**WATERTOWN
ROUTE 16 (MOUNT AUBURN STREET)**

POST DESIGN PUBLIC HEARING RENDERING
SHEET 1 OF 18

DESIGN RECOMMENDATIONS FROM PUBLIC PARTICIPATION PROCESS

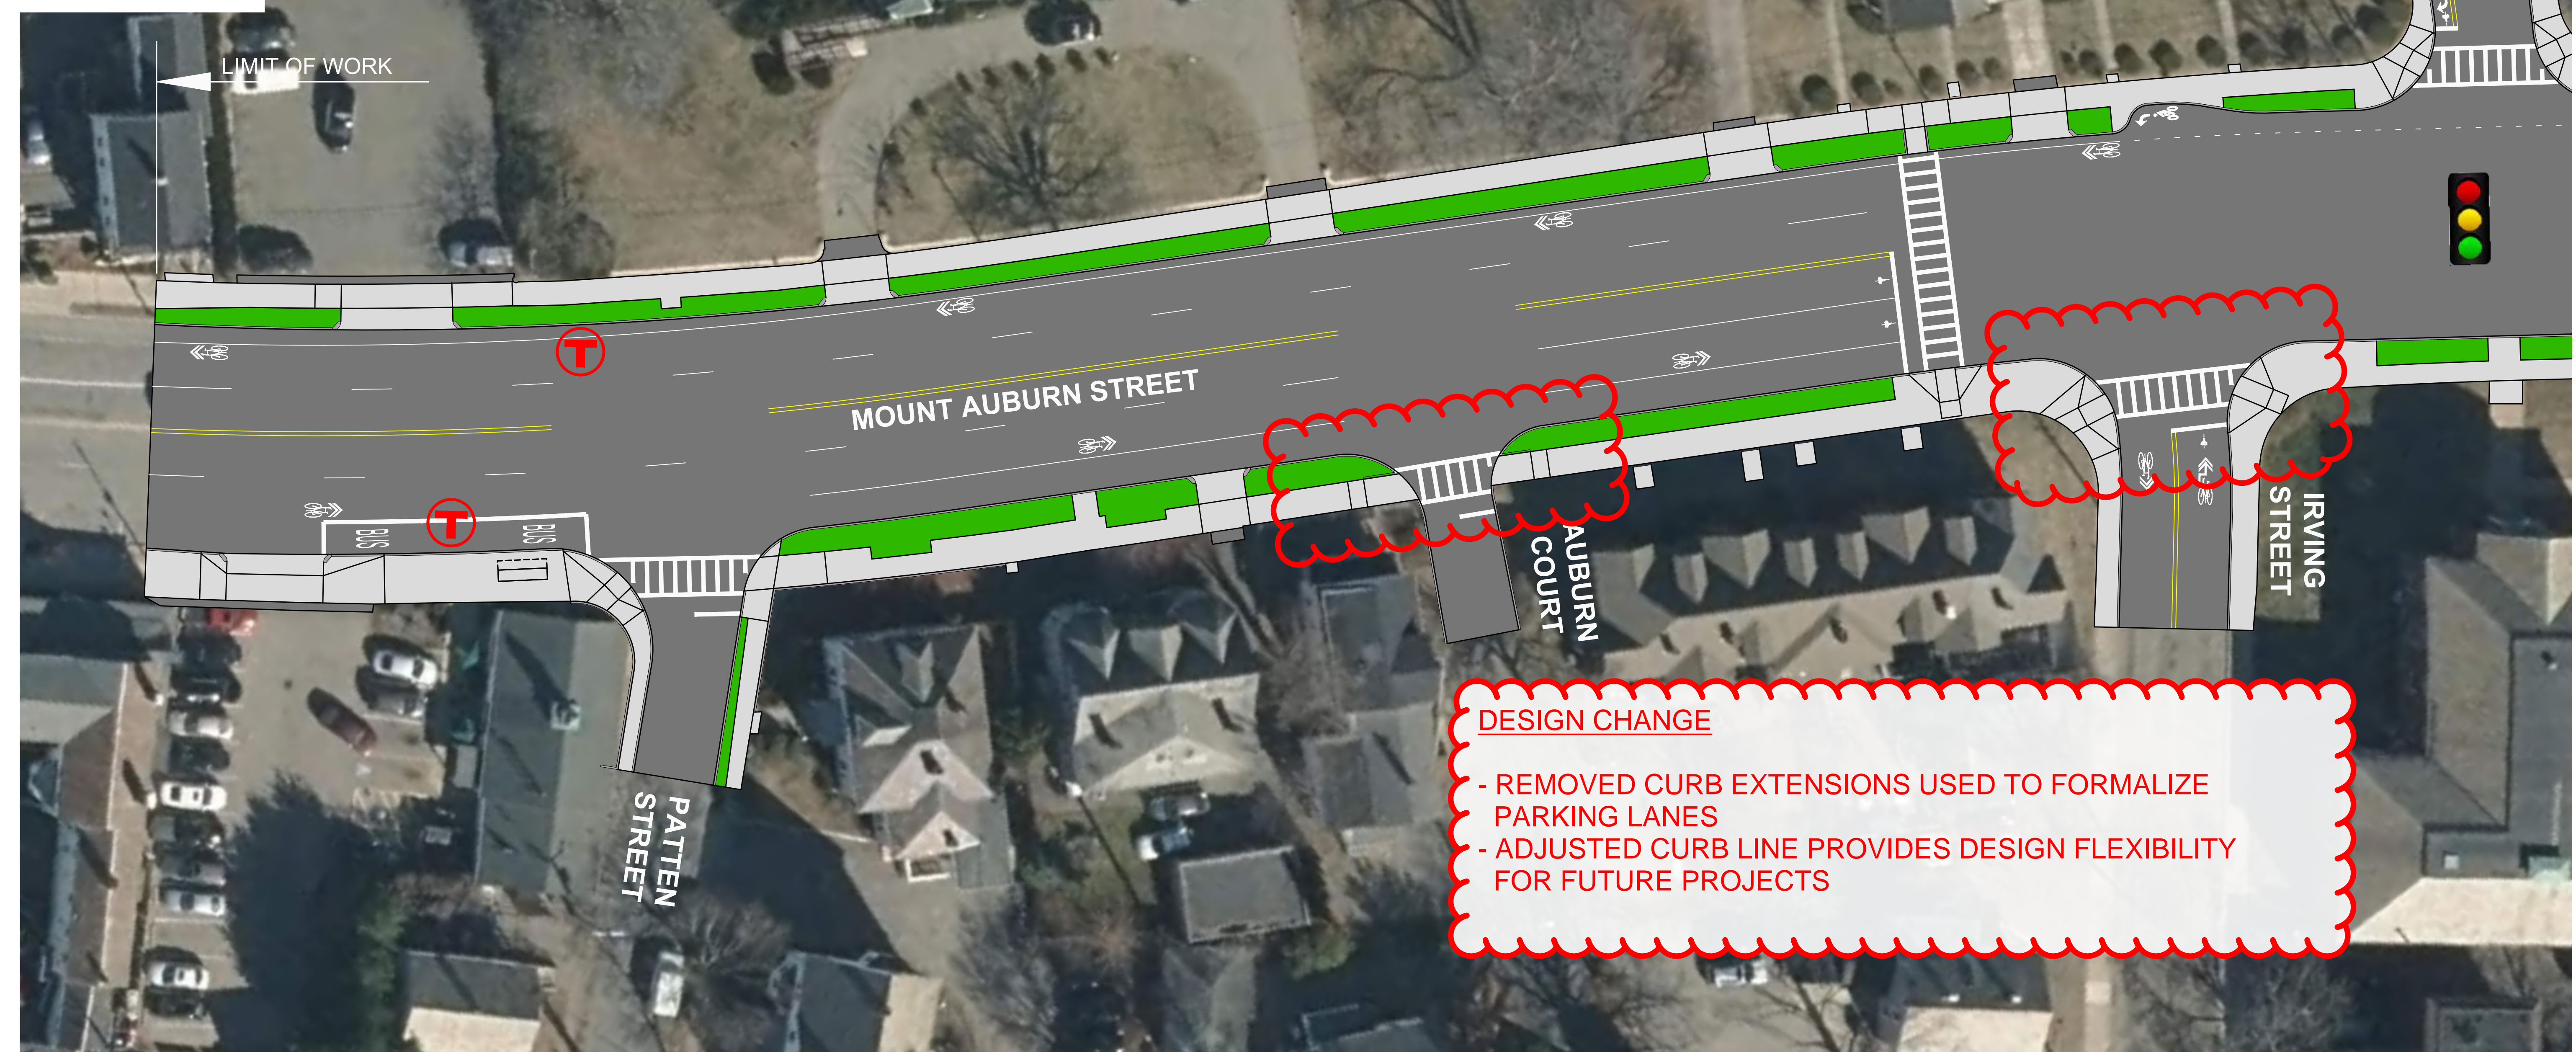
DESIGN CHANGE

- REMOVED CURB EXTENSIONS USED TO FORMALIZE PARKING LANES
- ADJUSTED CURB LINE PROVIDES DESIGN FLEXIBILITY FOR FUTURE PROJECTS

POST DESIGN PUBLIC HEARING RENDERING
SHEET 6 OF 18

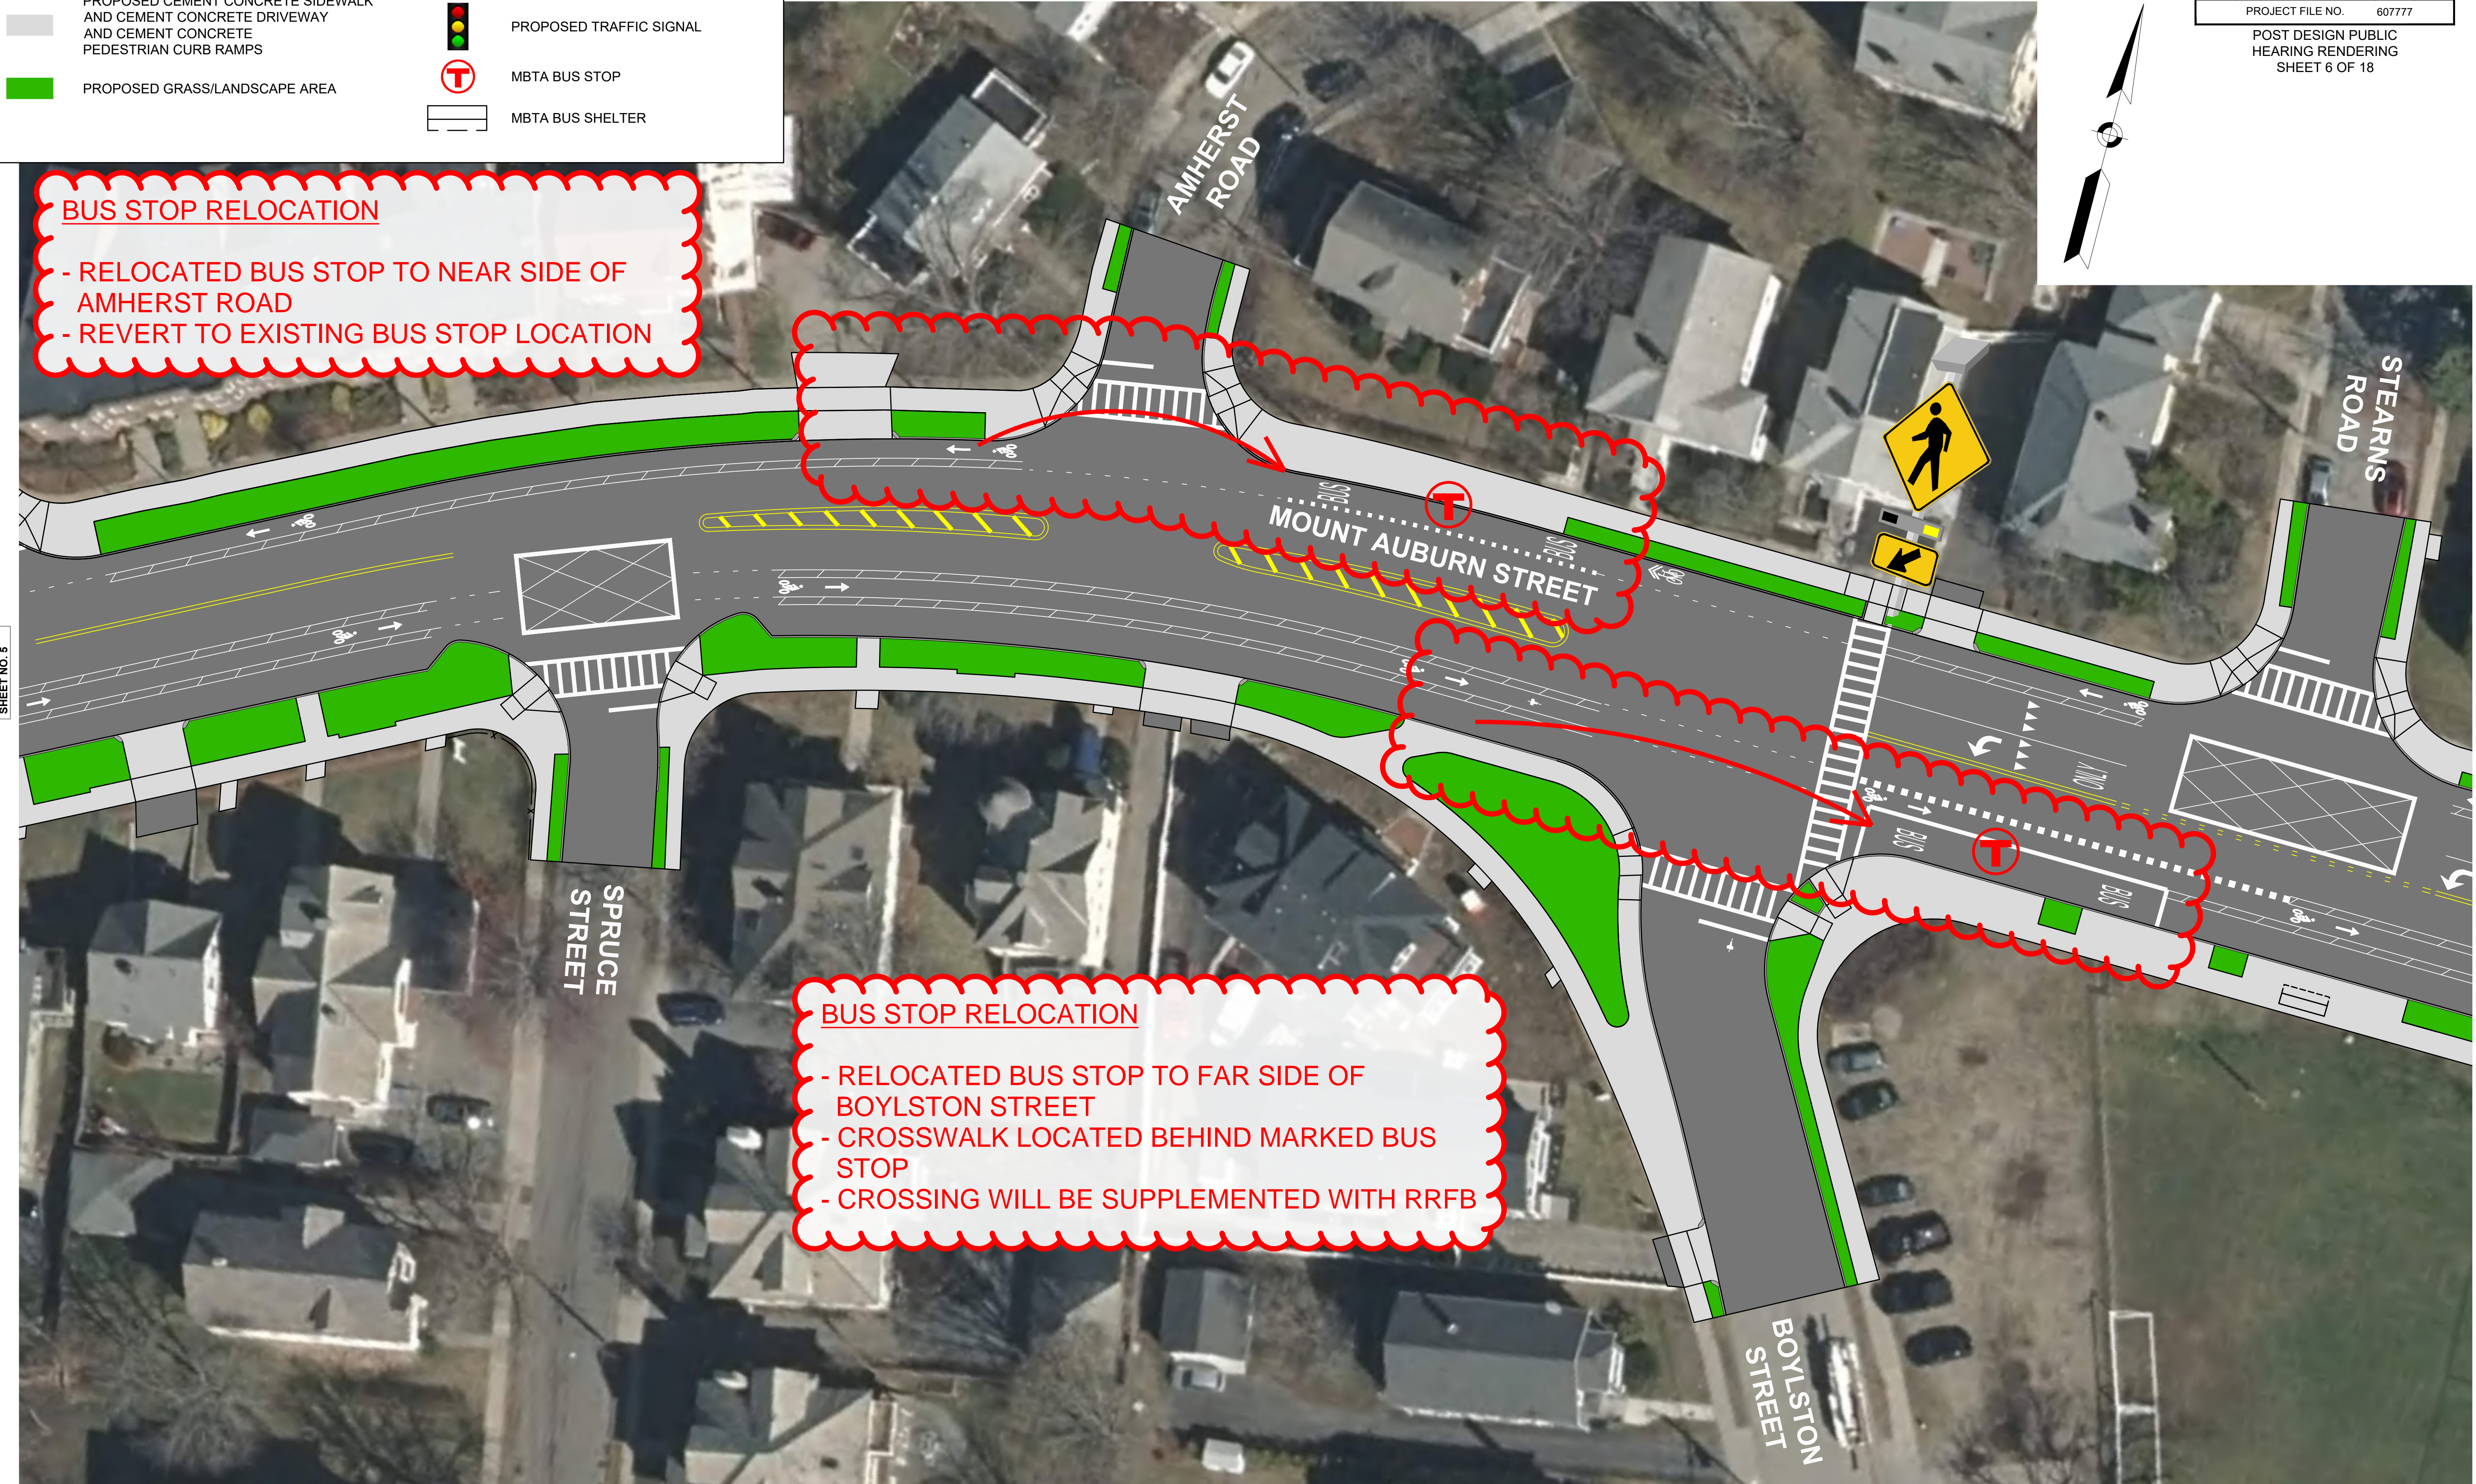
BUS STOP RELOCATION

- RELOCATED BUS STOP TO NEAR SIDE OF AMHERST ROAD
- REVERT TO EXISTING BUS STOP LOCATION

BUS STOP RELOCATION

- RELOCATED BUS STOP TO FAR SIDE OF BOYLSTON STREET
- CROSSWALK LOCATED BEHIND MARKED BUS STOP
- CROSSING WILL BE SUPPLEMENTED WITH RRFB

POST DESIGN PUBLIC
HEARING RENDERING
SHEET 8 OF 18

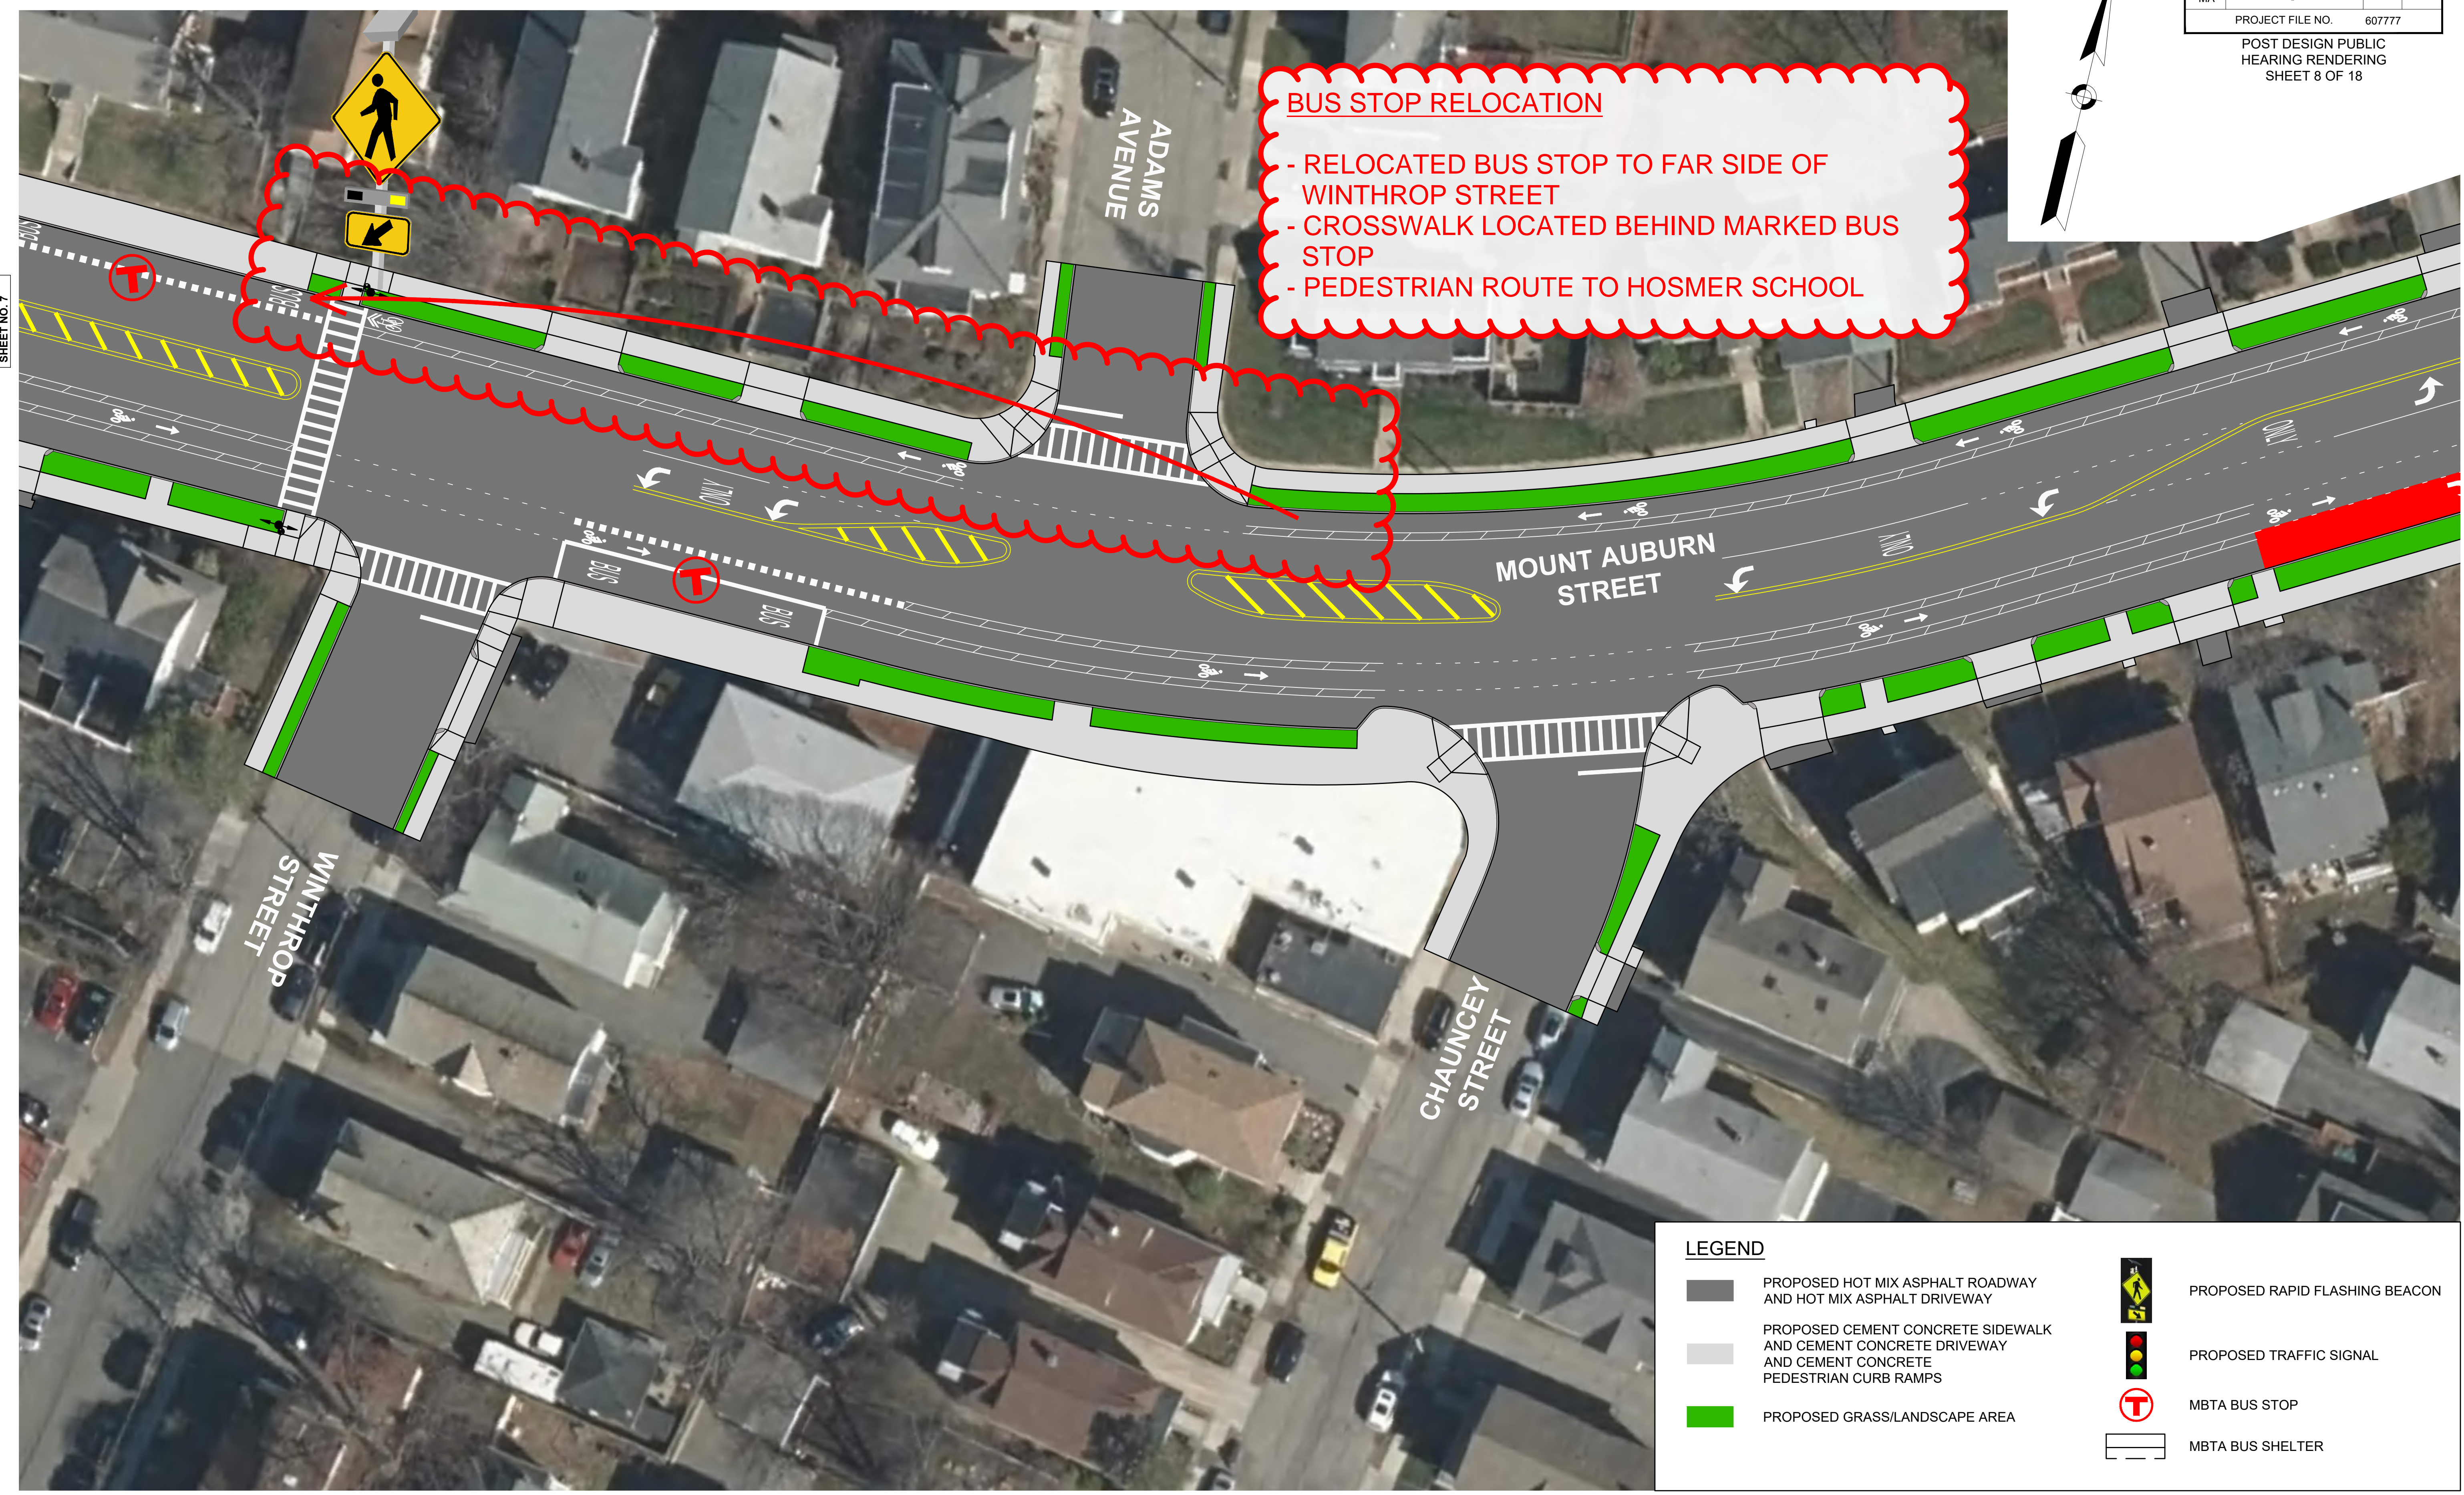
BUS STOP RELOCATION

- RELOCATED BUS STOP TO FAR SIDE OF WINTHROP STREET
- CROSSWALK LOCATED BEHIND MARKED BUS STOP
- PEDESTRIAN ROUTE TO HOSMER SCHOOL
